Response to egusphere-2026-1291:

Summary of the overall improvements of the revised version:

Modified Fig. 11. Top panel is from yes-PD fullset model prediction, while the bottom panel is from no-PD subset model prediction (in the revised version, panel #4 is removed due to redundancy).

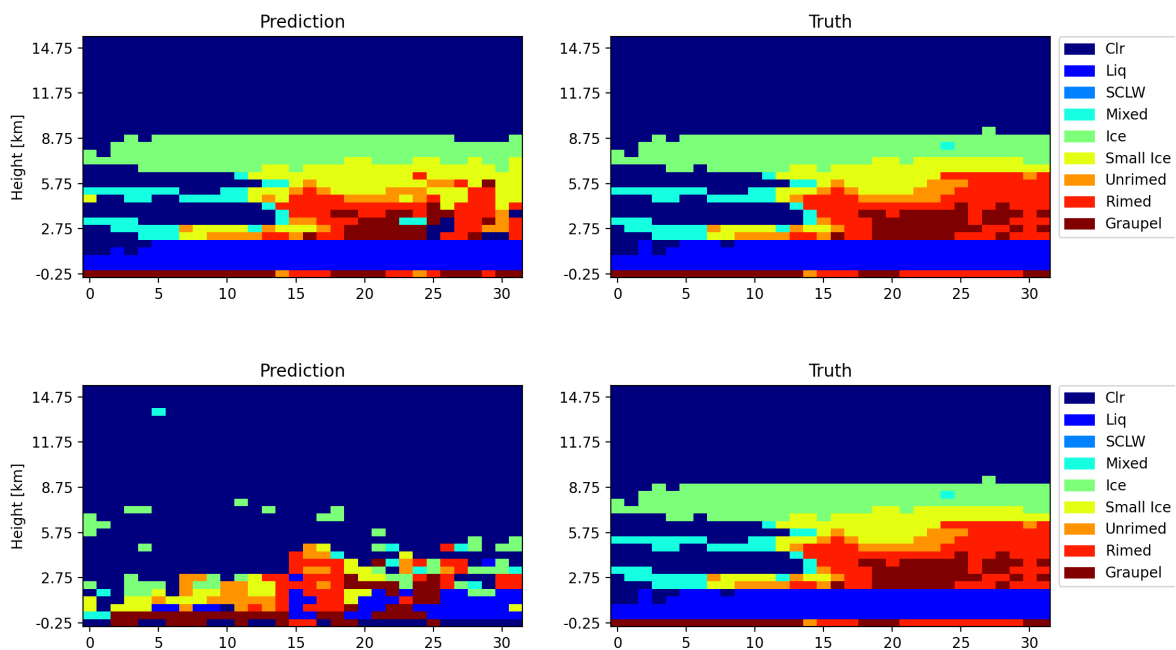
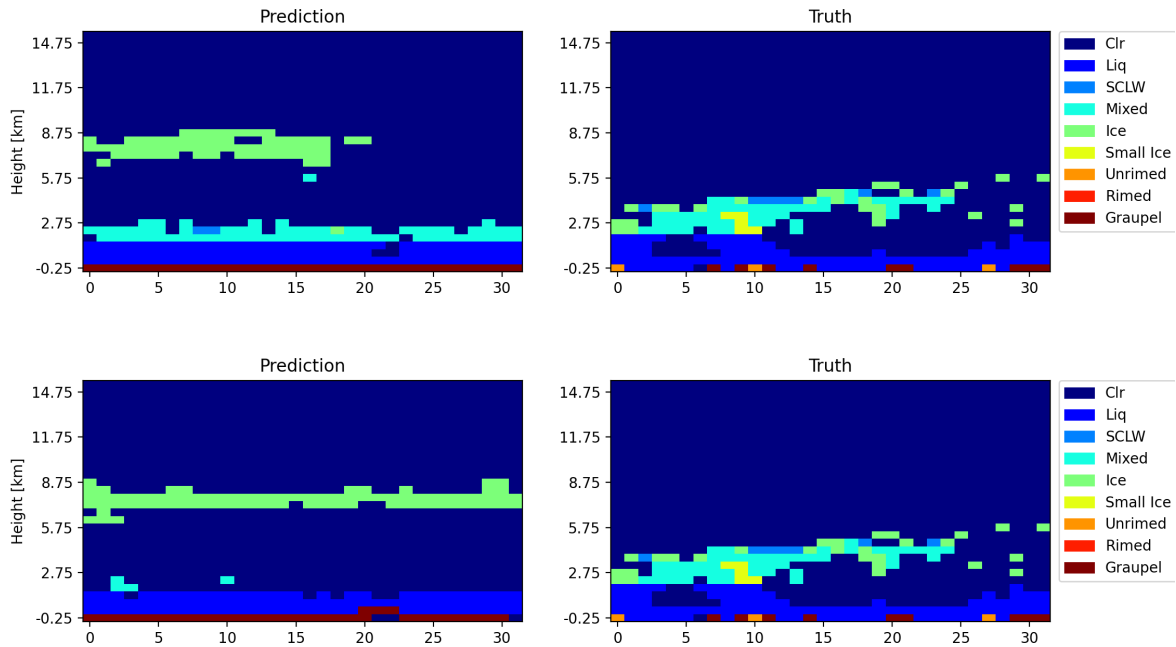
In Fig. 11, the two panels showing the reference (11b and 11d) are not the same. Rather, it looks like panel d has a small horizontal offset compared to panel b. Were the targets not exactly the same for both models? Or is it a plotting artifact? If the latter, then I suggest plotting the same reference for both to aid comparison between models, or at least making the difference between the two clearer through the choice of variable on the x-axis. The same applies to Fig. 12.

Thank you for catching that. Now the figures in the revised manuscript have been updated to keep the “truth” identical for all cases showing (hence reduced from 2X2 panels to 3X1 panels for Fig. 11 and Fig. 12). The second planetary boundary layer (PBL) cloud case is replaced with a more complicated two-layer broken PBL cloud scenario to showcase that while both ML models predict a wrong thin ice cloud layer in the upper troposphere, the yes-PD model still makes a better prediction for the PBL mixed-phase cloud above the liquid layer than the no-PD model. The written text also changed accordingly. See below for the cases used in the modified Fig. 11 and Fig. 12, respectively.

Same with modified Fig. 11, except for a PBL two-layer cloud case.

The independent testing dataset contains 432 images, and they are randomly grouped into 29 batches with each batch containing 16 images for prediction. Therefore, when we call the ML model each time to generate the prediction, the image order is randomized, and I had to visually identify the ones with the same “truth”. I have now uploaded the entire prediction image sets on the zenodo link (<https://doi.org/10.5281/zenodo.19161985>, version 2; under “Triple_freq_paper_ML.tgz” -> “prediction_figures” folder). Please take a look if you are interested.

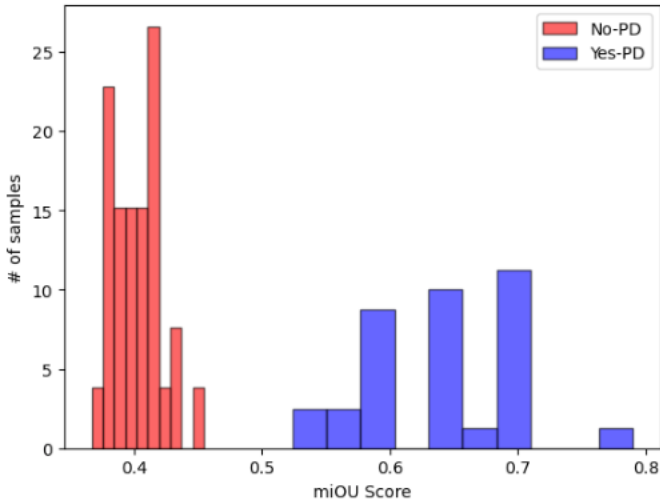
The improvement upon including PD measurements is very clearly illustrated in Figs. 11 and 12, and quite impressive. Although, as the authors mention, the no-PD model does appear to capture the cloud top for the multi-layer thick cloud, it does seem to struggle overall. Likewise, it gives a false cloud for the single layer cloud case. It was therefore surprising that it achieves an mIoU score of 0.545, which the authors frame earlier as a typically good result. Do the authors attribute this to the model's ability to capture the cloud top/thickness, or did it perform better in other scenes than those shown?

Thanks for helping us identifying a code bug. The mIoU score for the no-PD model was actually wrongly computed, and it should be 0.4024, while the mIoU score for the fullset yes-PD model remains to be 0.642.

Please see the mIoU score distribution amongst all 432 independent prediction samples below.

The “yes-PD” (i.e., fullset) model consistently outperforms the “no-PD” (i.e., subset) model for geometrically thick cloud cases. For thin cloud cases, they are equally bad, especially for thin boundary layer cloud scenarios, but the “yes-PD” prediction in general looks in better agreement with the “truth”. The miOU score statistics can be found on the zenodo link (<https://doi.org/10.5281/zenodo.19161985>; version 2) under “Triple_freq_paper_ML.tgz”->“predictions”->“iou_score_prediction_statistics”.

Fig. 5 plus hatched area in panel (a) to outline the mixed-phase regime where LWC and IWC co-exist.

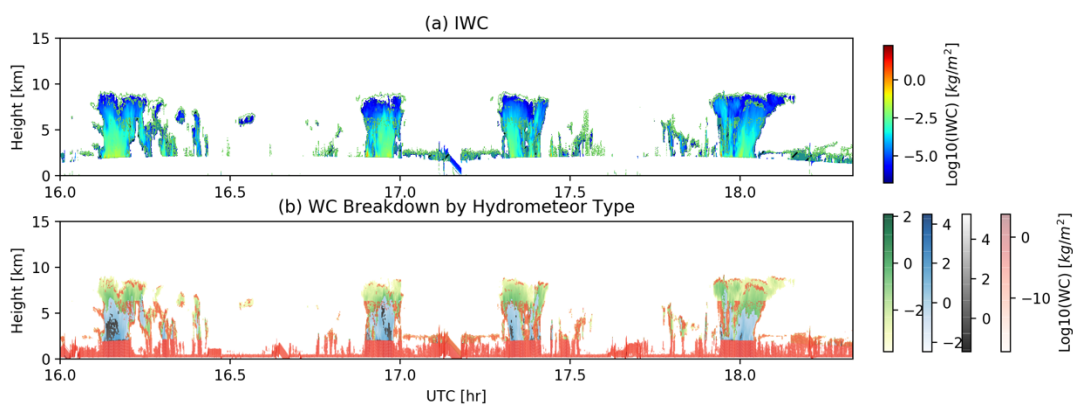
Figure 5: The interpretation of the figure would be simplified by using \log_{10} , instead of \log . The color ranges are very wide and appear poorly adjusted. For example some of the color ranges reach 10, matching 22000 kg/m². For IWC, the lower end is at -40, matching 4e-18 kg/m². The colorbar ticks are partially covered by the colorbars. It would also be helpful to clearly differentiate in the figure where the separate overpasses start and end, if possible to do so clearly.

Thanks for the suggestion. We have now updated the colorbar to \log_{10} and adjusted the colorbar locations to avoid overlapping. I'm not quite sure if I understand your suggestion about "separate overpasses start and end". If you meant to suggest mark the boundaries of overlapping areas where IWC and LWC co-exists, I think it would make the figure too busy and harder to read. I've decided to not include that in the updated Fig. 5, but just to show you what it looks like in case you feel it's better than the current Fig. 5:
